Device	XMC4700/XMC4800
Marking/Step	ES-AA, AA
Package	PG-LQFP-100/144, PG-LFBGA-196

Document ID is **03508AERRA**.

This “Errata Sheet” describes product deviations with respect to the user documentation listed below.

Figure 1 Parity Checker diagram

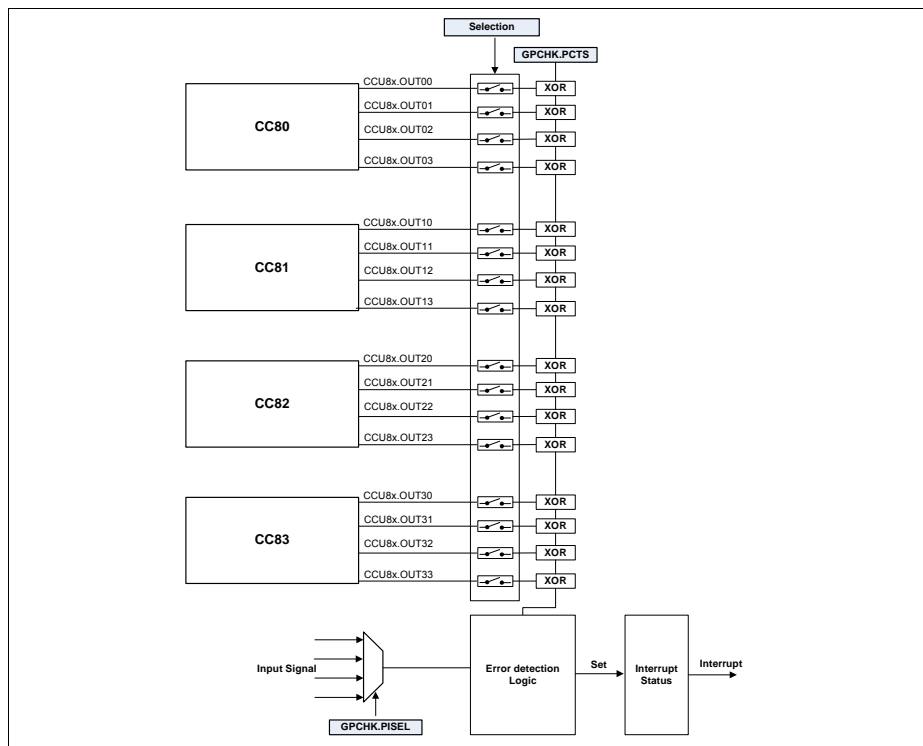
When using the parity checker function, the associated status bitfield, is cleared automatically by hardware in the next PWM cycle whenever an error is not present.

This means that if in the previous PWM cycle an error was detected and one interrupt was triggered, the software needs to read back the status register before the end of the immediately next PWM cycle.

This is indeed only necessary if multiple interrupt sources are ORed together in the same interrupt line. If this is not the case and the parity checker error source is the only one associated with an interrupt line, then there is no need to read back the status information. This is due to the fact, that only one action can be triggered in the software routine, the one linked with the parity checker error.

Not ORing the Parity Checker error interrupt with any other interrupt source. With this approach, the software does not need to read back the status information to understand what was the origin of the interrupt - because there is only one source.

Figure 2 Clock Selection Diagram for CCU4

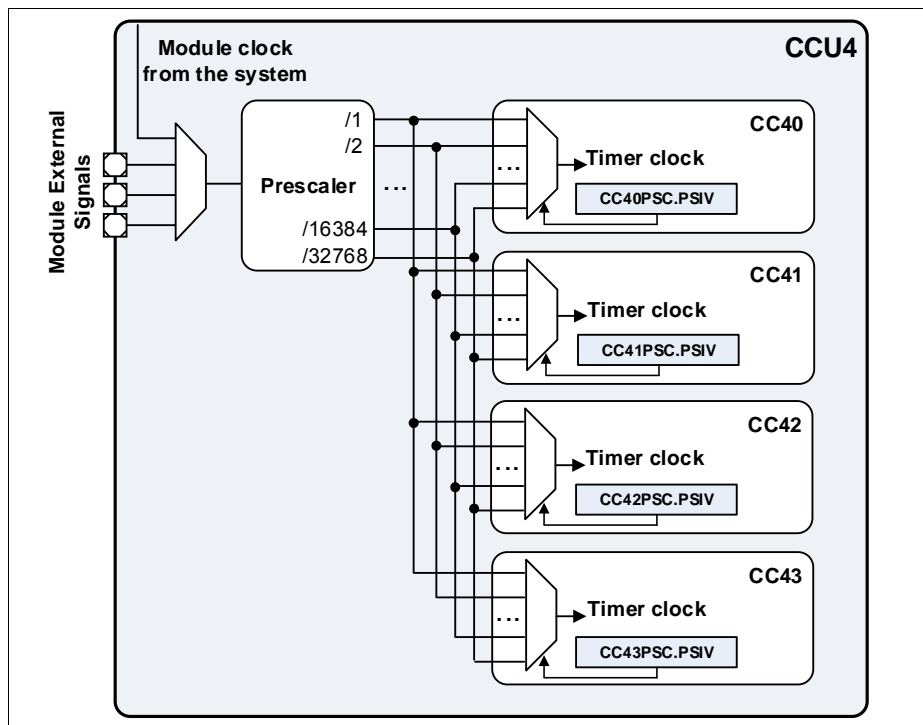
Currently is only possible to use an external signal as Timer Clock when a division ratio of 2 or higher is selected. When no division is selected (divided by 1), the external signal cannot be used.

The user must program the PSIV field of each Timer Slice with a value different from 0000_B - minimum division value is /2.

None.

Figure 3 PADT update behavior

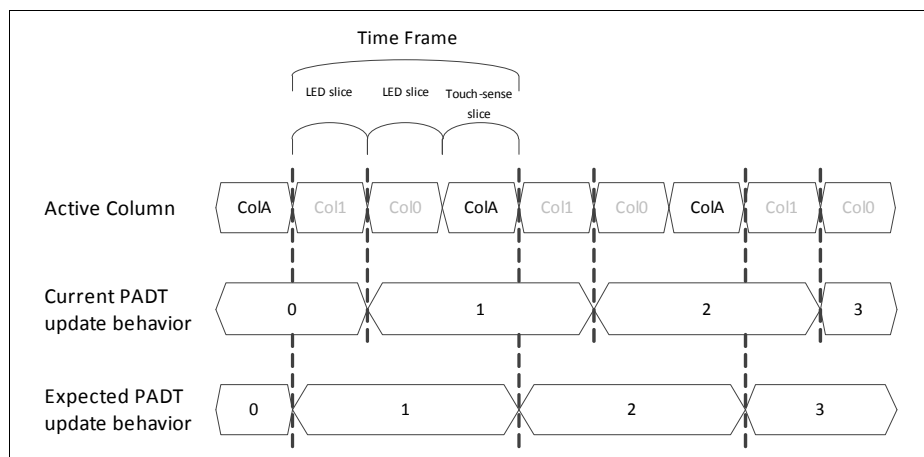
The touch-sense pad turn (PADT) value is updated, not at the end of the touch-sense time slice (ColA), but one time slice later ([Figure 3](#)).

Figure 4 Effect of delay on the update of Internal Compare Register with 1 LED column enabled

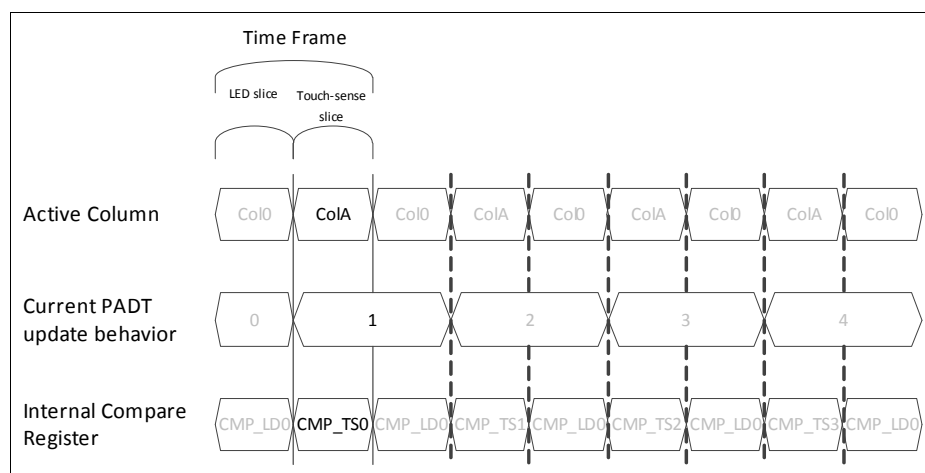
If the number of LED columns enabled is smaller than 2, the delay will affect the activation period of the current active pad. At the beginning of every new Col A, the value of the current PADT's compare register is updated to the internal compare register. However, the delay causes the value of the previous PADT's compare register is updated to the internal compare register instead. This means that the current active pad would be activated with the duration of the previous pad's oscillation window (**Figure 4**). In addition to this, when no LEDs are enabled, pad turn 0 will prevail for one time slice longer before it gets updated (**Figure 5**).

Figure 6 Internal Compare Register updated with correct compare register value with 2 LED columns enabled

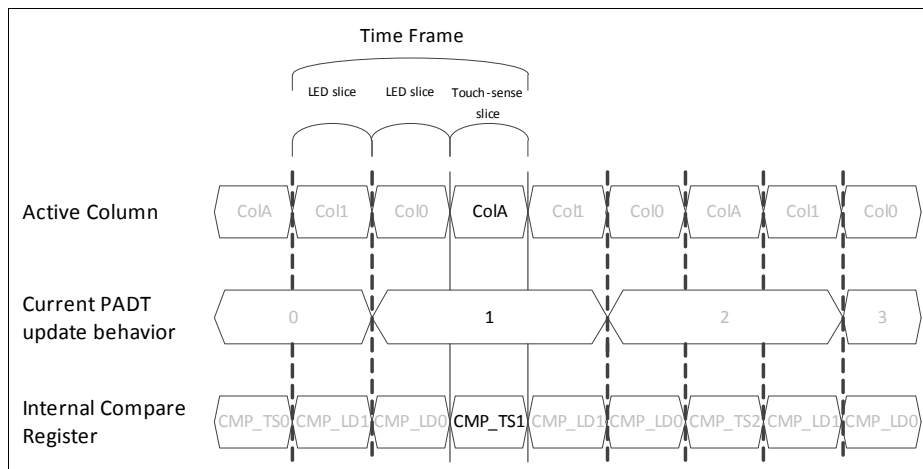
If the number of LED columns enabled is 2 or more, the additional LED columns would provide some buffer time for the delay. So, at the start of a new touch-sense time slice, the update of PADT value would have taken place. Hence, the current active PADT compare register value is updated to the internal compare register ([Figure 6](#)).

Figure 8 Rotary Encoder outputs - Phase A, Phase B and Index

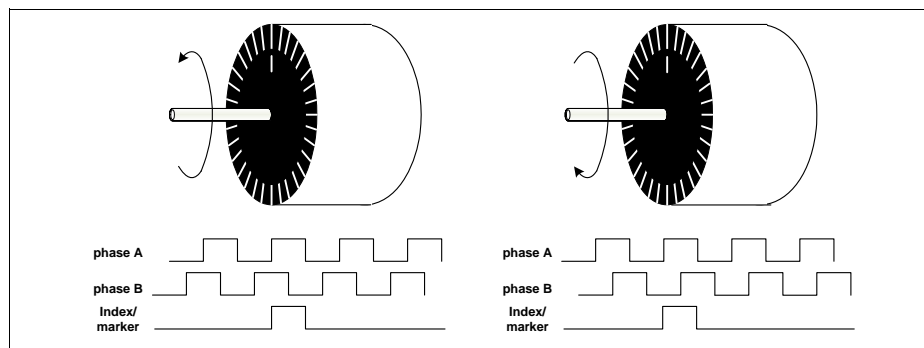
Each POSIF module can be used as an input interface for a Rotary Encoder. It is possible to configure the POSIF module to decode 3 different signals: Phase A, Phase B (these two signals are 90° out of phase) and Index. The index signal is normally understood as the marker for the zero position of the motor Figure 1.

Figure 9 Different index signal types

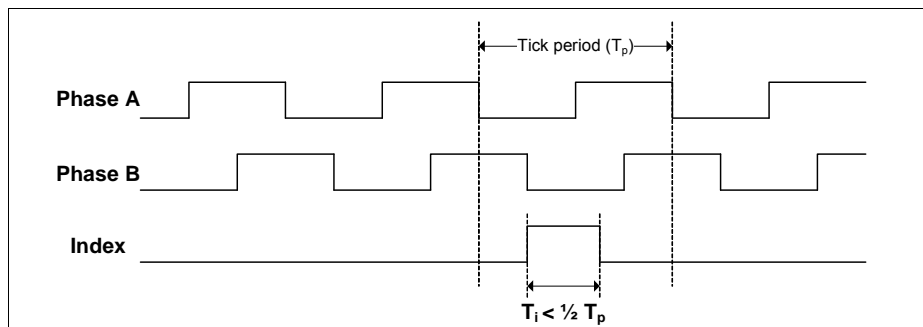
When the index signal is smaller than 1/2 of the tick period, the POSIF module is not able to decode this signal properly, Figure 2 - notice that the reference edge of the index generation in this figure is the falling of Phase B, nevertheless this is an example and depending on the encoder type, this edge may be one of the other three.

Due to this fact it is not possible to use the POSIF to decode these type of signals (index with duration below 1/2 of the tick period).

Figure 11 Alert Interrupt Behavior in case of Bus-Off

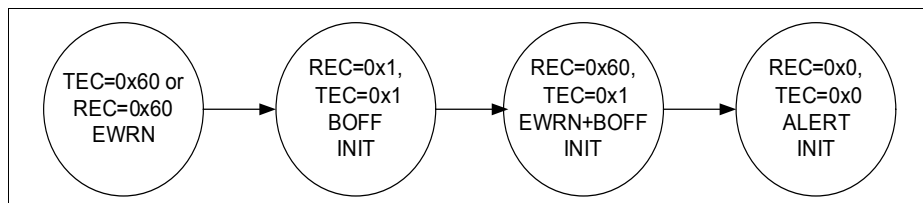
The MultiCAN module shows the following behavior in case of a bus-off status:

When the threshold for error warning (EWRN) is reached (default value of Error Warning Level EWRN = 0x60), then the EWRN interrupt is issued. The bus-off (BOFF) status is reached if $TEC > 255$ according to CAN specification, changing the MultiCAN module with REC and TEC to the same value 0x1, setting the INIT bit to 1_B, and issuing the BOFF interrupt. The bus-off recovery phase starts automatically. Every time an idle time is seen, REC is incremented. If REC = 0x60, a combined status EWRN+BOFF is reached. The corresponding interrupt can also be seen as a pre-warning interrupt, that the bus-off recovery phase will be finished soon. When the bus-off recovery phase has finished (128 times idle time have been seen on the bus), EWRN and BOFF are cleared, the ALERT interrupt bit is set and the INIT bit is still set.
